HISTORIC AND DESIGN REVIEW COMPLIANCE AND TECHNICAL ADVISORY BOARD

HDRC CASE NO: 2024-312
ADDRESS: 2611 N MAIN AVE
LEGAL DESCRIPTION: NCB 1836 BLK 11 LOT 15, 16, 17, 18
ZONING: C-2, H
CITY COUNCIL DIST.: 1
DISTRICT: Monte Vista Historic District
APPLICANT: Frank Telles | FT Builder Services LLC
OWNER: Kim Ross | Ross Real Estate Ventures LLC
TYPE OF WORK: Window replacement
APPLICATION RECEIVED: August 15, 2024
60-DAY REVIEW: October 14, 2024
CASE MANAGER: Bryan Morales

The applicant is requesting a Certificate of Appropriateness for approval to install new windows on the left (south) facade to feature internal faux muntins.

New Request (South Facade)

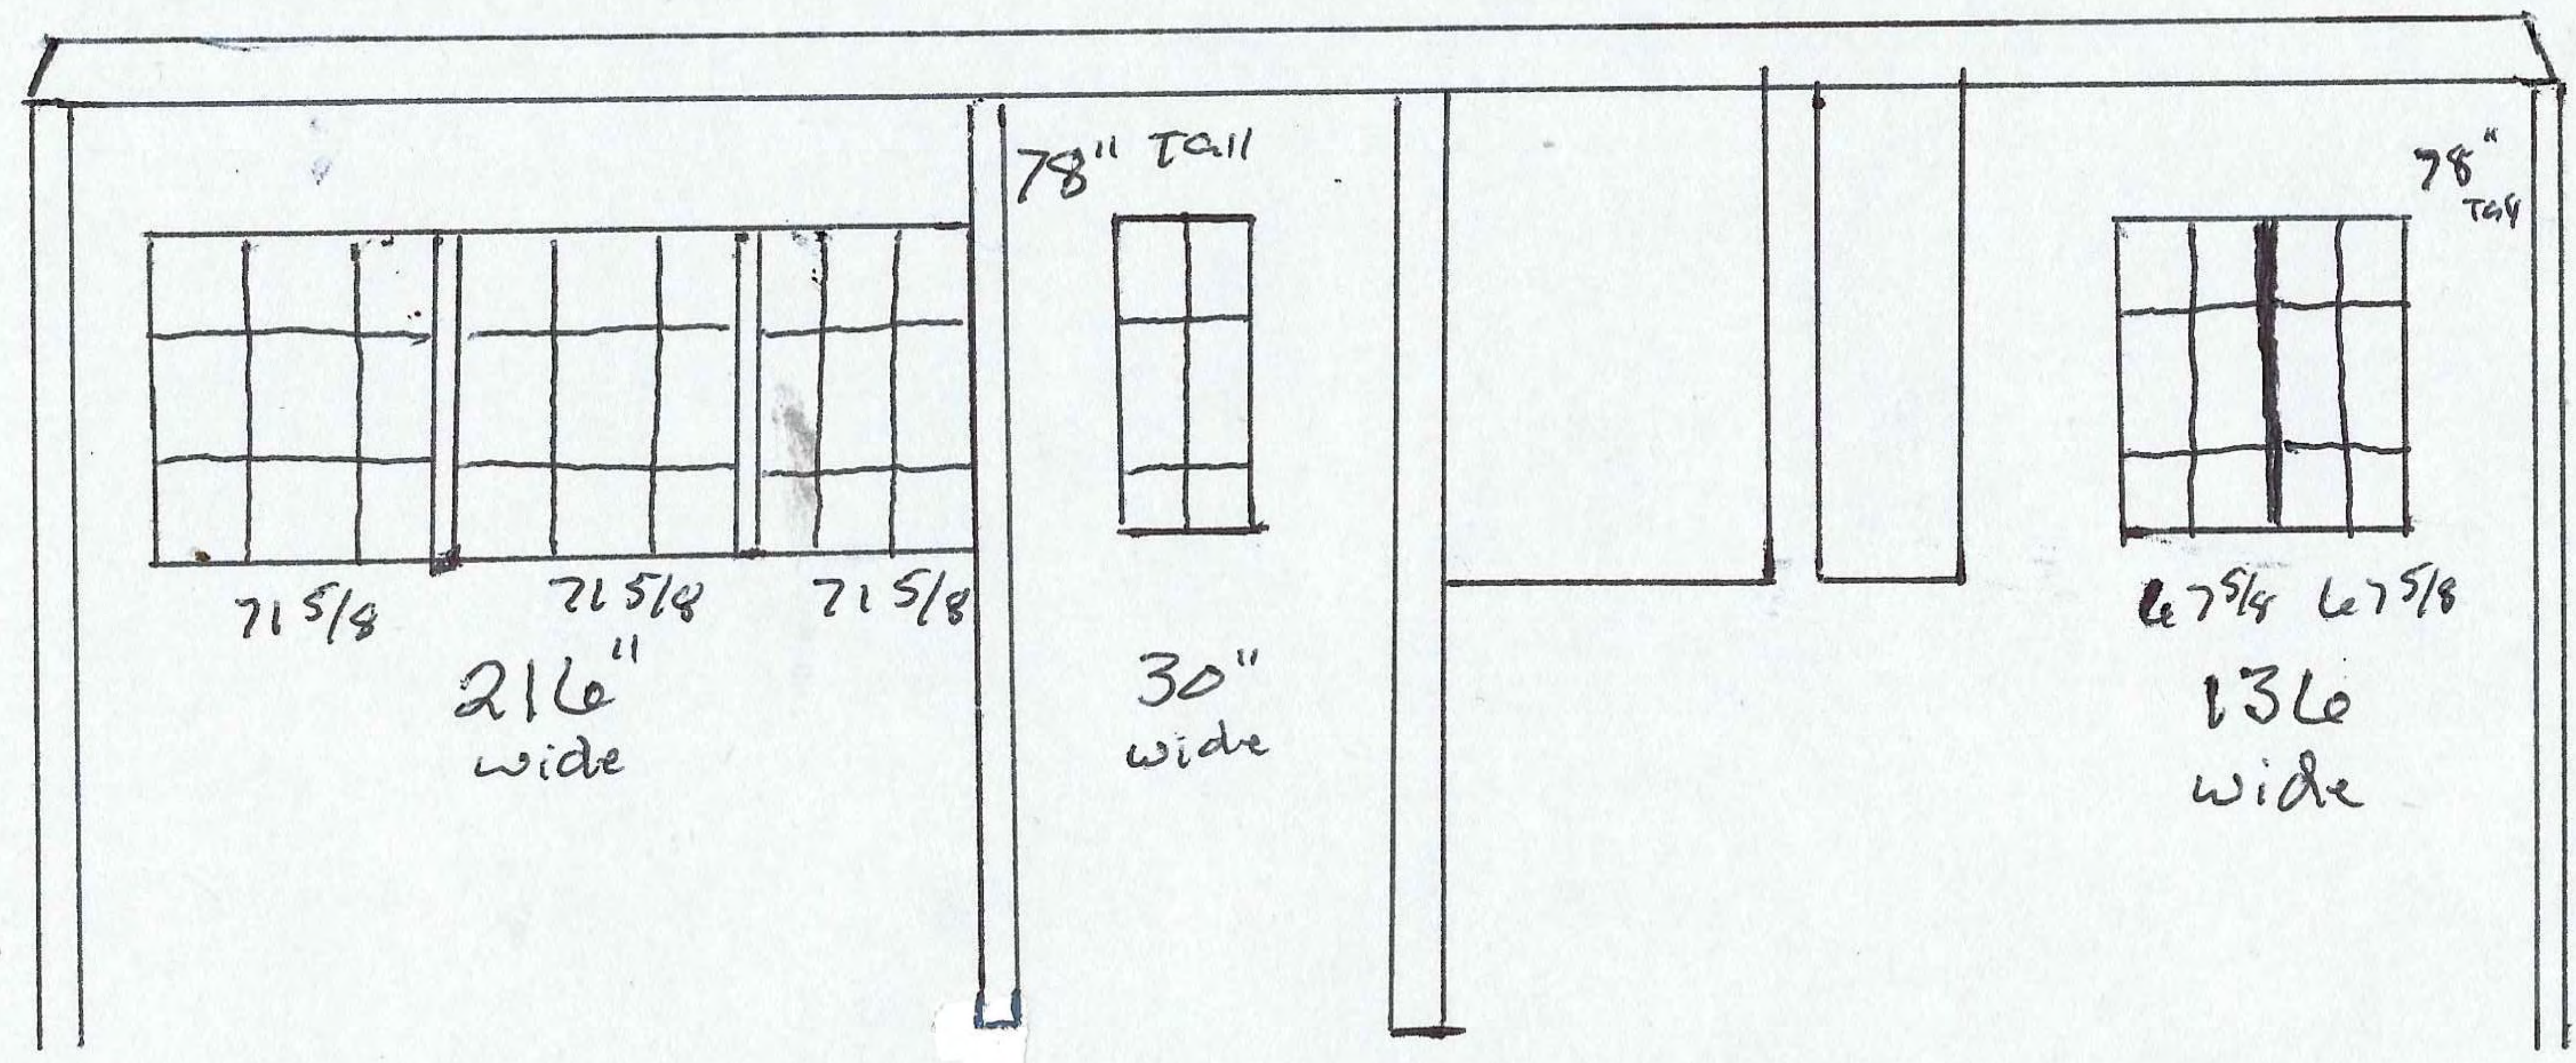
- c. WINDOW REPLACEMENT – The applicant is requesting approval to install new windows on the left elevation to feature internal faux muntins. The Historic Design Guidelines for Exterior Maintenance and Alterations 6.B.v. states to use the exterior muntin pattern, profile, and size appropriate for the historic building when replacement windows are necessary and to not use internal muntins sandwiched between layers of glass. Staff finds the installation of the windows featuring internal faux muntins does not conform to Guidelines.

Staff does not recommend approval of the request, based on findings a through c. Staff recommends the applicant install the previously approved window system.
